Re: Chino Administrative Order on Consent (AOC)
Feasibility Study for the Smelter Tailings Soils Investigation Unit

Freeport-McMoRan Chino Mines Company – Administrative Order on Consent Response to New Mexico Environment Department Comments on the Smelter Tailing Soils Investigation Unit Feasibility Study

This document presents Freeport-McMoRan Chino Mines Company's (Chino) response to comments on the Feasibility Study (FS) for the Smelter/Tailing Soils Investigation Unit (STSIU), dated October 3, 2026. The comments were received from the New Mexico Environment Department (NMED) in a letter date January 28, 2026. The FS was prepared in accordance with the Scope of Work associated with the Administrative Order on Consent (AOC) between Chino and NMED. The FS has been revised to address NMED comments and the below provides Chino's response in *italics* to each of those comments.

FIGURE 3-10

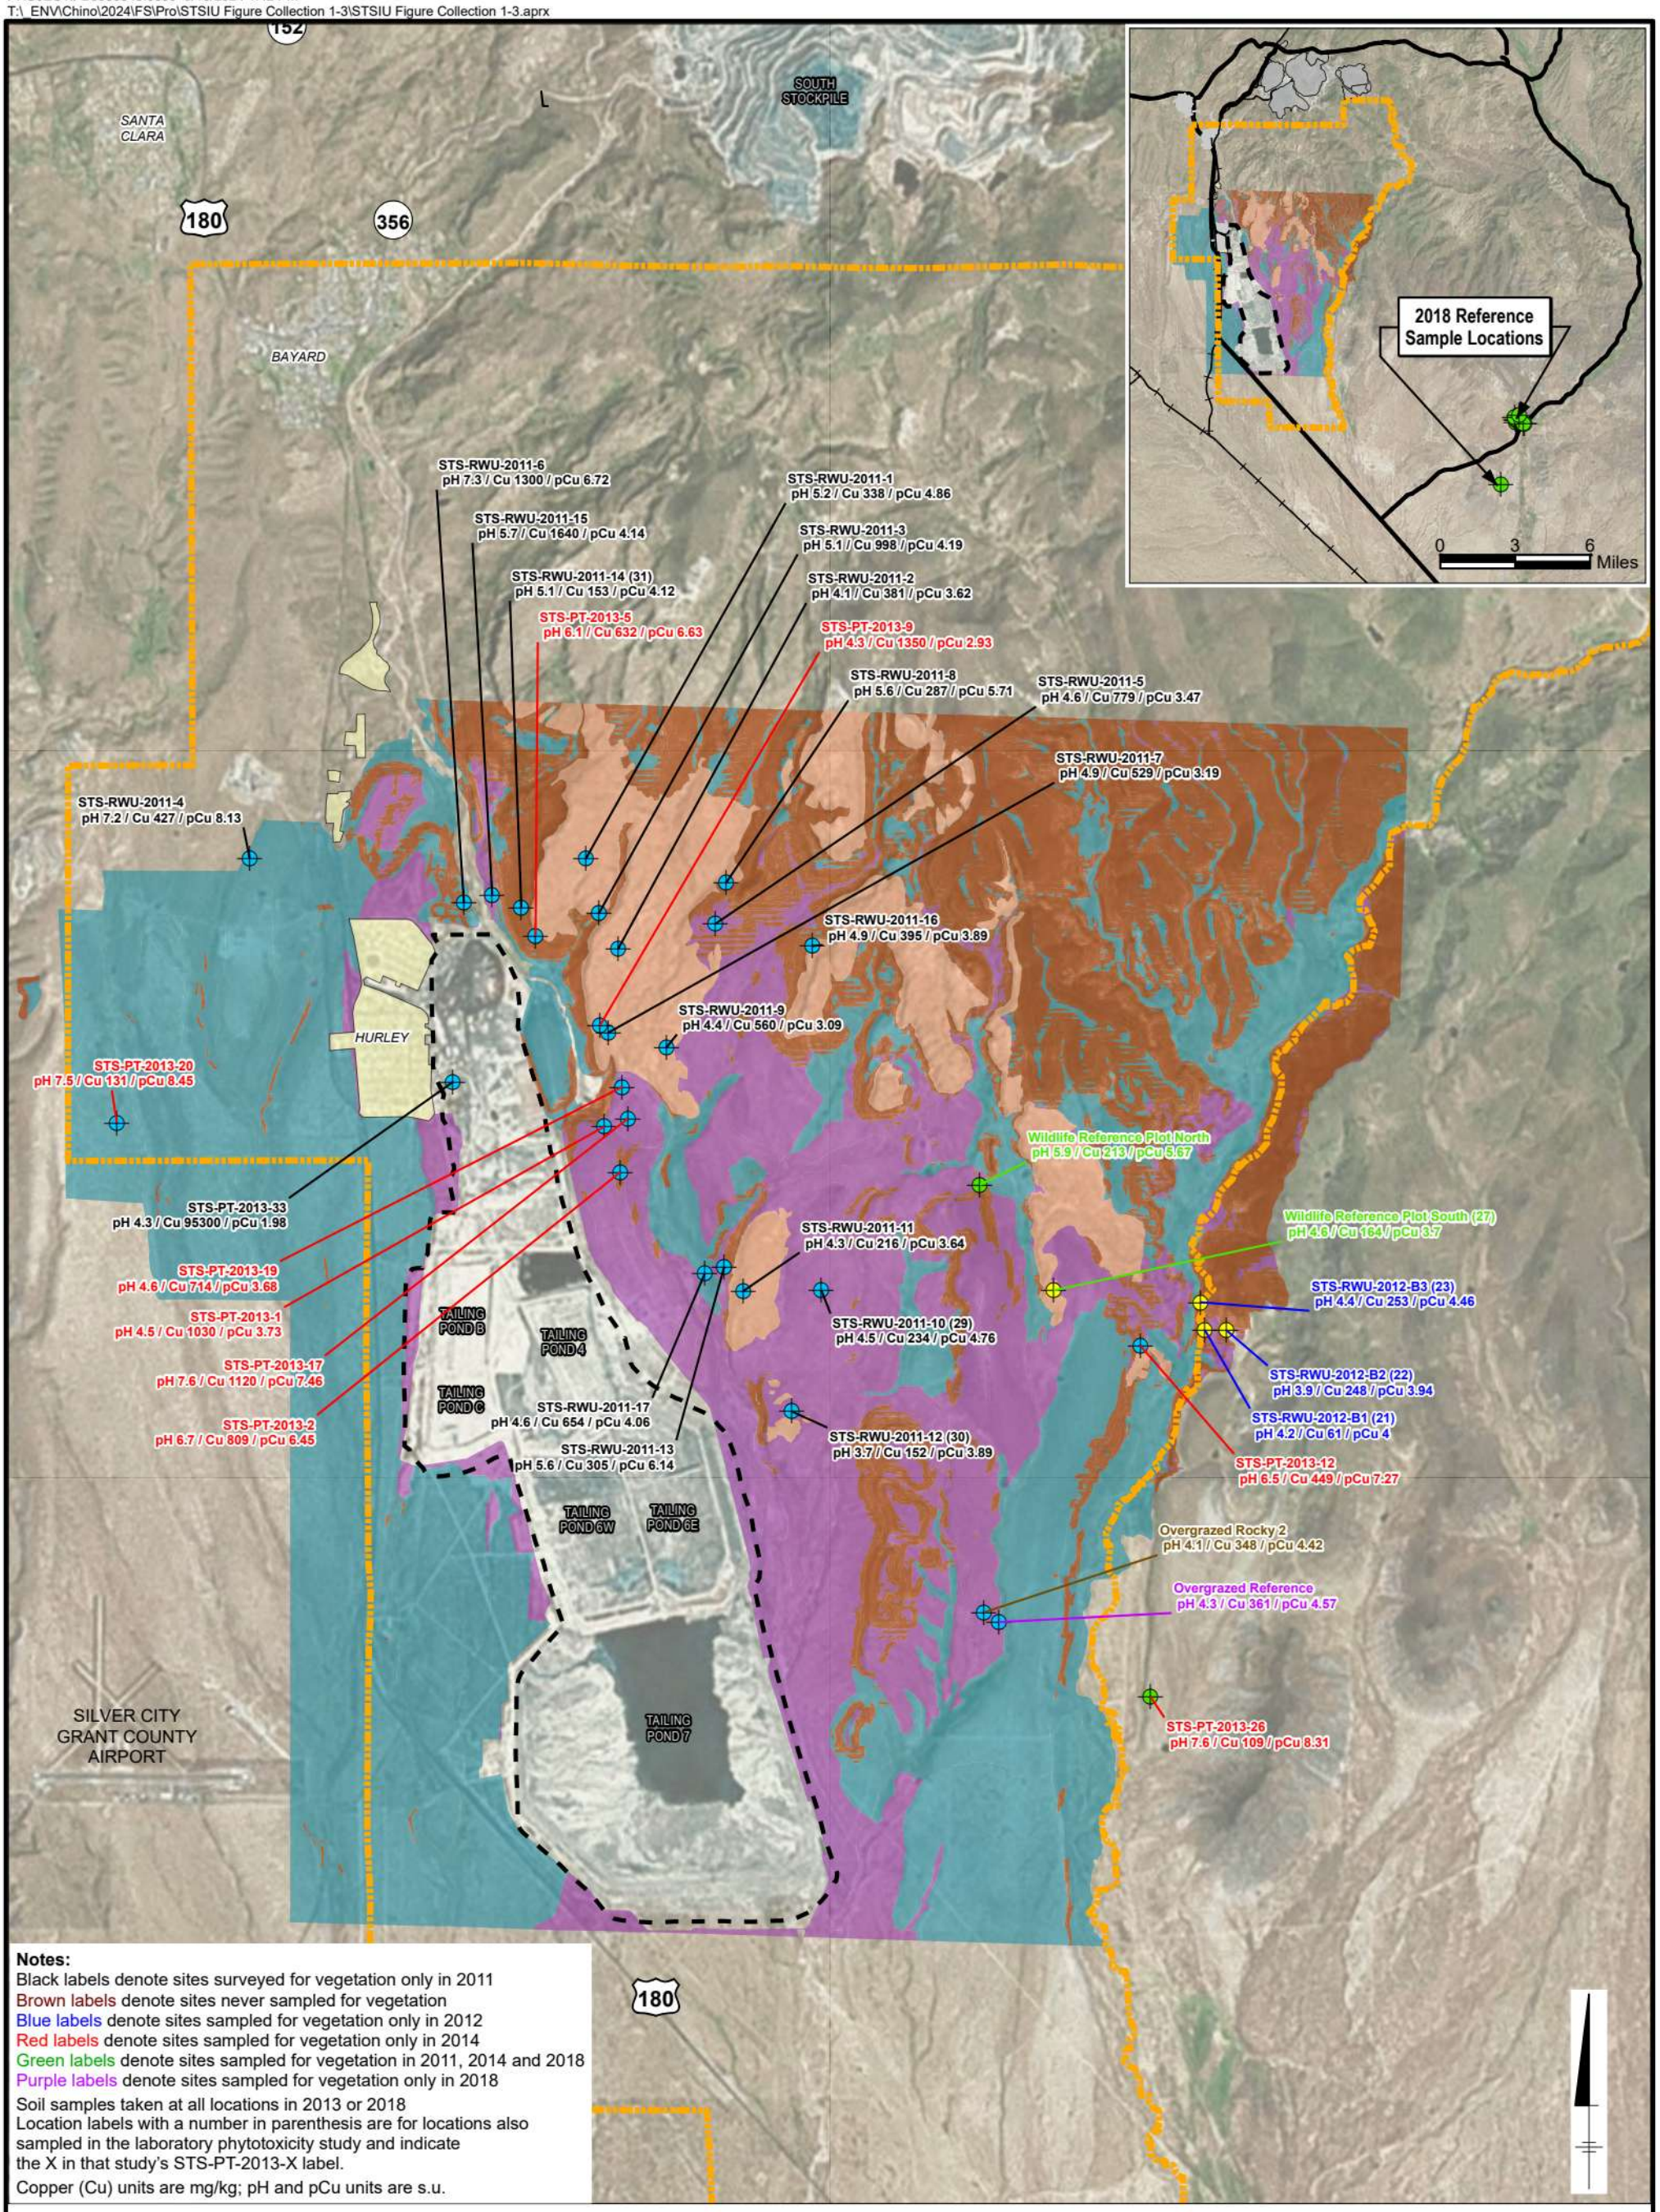
SC-14. P 8. Provide a quantitative analysis of the buffering capacity difference in the rhyolite-derived and other andesitic basalt or Gila Conglomerate Formation soils.

> **Chino Response:** *Buffering capacity of site soils was not quantified in the laboratory but acid base accounting results in Bengston (2019) indicated high net neutralization potential (neutralization potential ratio of 11 to 752) in the Gila Conglomerate Formation. It contains calcite, which can buffer pH in soils, and its pH has been shown to range from 7 to 8.2 (Bengston 2019[5]). This matches the finding in Appendix B that the Gila-Conglomerate-derived soils west of the former smelter (REF 1 in Figure 23) have high NNP. Rhyolite bedrock and Kneeling Nun bedrock are volcanic rock (do not have calcite); their bedrock pHs on the site were analyzed and found to be lower than the Gila Conglomerate Formation, ranging from 5 to 6.4 and 6.35 to 7.4, respectively (Figure F-1 of Attachment A in Appendix D of the FS). Citations to these sources were added.*
>
> *Figure 3 of Appendix D of the FS provides a geologic map, which shows the location of the Gila Conglomerate Formation (Qts/Qfl), which is dominant on the western and far eastern sides of the site. The map also shows rhyolite-based formations that are common near the old smelter site and tailings on the east side, including rhyolite-based fan deposits (Qfr), Sugarlump tuff (Tsl), Kneeling Nun tuff, and many other types described as having reddish or light gray rock. Andesite basalt-derived formations on the site include Qfb fan deposits farther east from the tailings, derived from basalt that has a dark gray to black color. These rocks are alkalic (contain MgO, CaO, and K_2O; Fodor 1975), producing higher pH soils. The chemistry of these formations affects the chemistry of their soils. Generally, the more calcite in the soil, the higher the buffering capacity. See Figure D-15 of Appendix D, which quantified $CaCO_3$ and alkalinity in soils on the site. This Figure shows that, except when very close to the smelter, the flat granular (FG) soil category, which often were found in non-rhyolitic derived soils, generally had higher lime and alkalinity than flat rocky (FR) soils which were derived from rhyolite (piper diagrams of the soil and rhyolite bedrock*

chemistry including bicarbonate ions are also shown in Figure F-2 of Attachment A of Appendix D of the FS). The soil categories referenced are shown on Figure 3-10 of the FS.
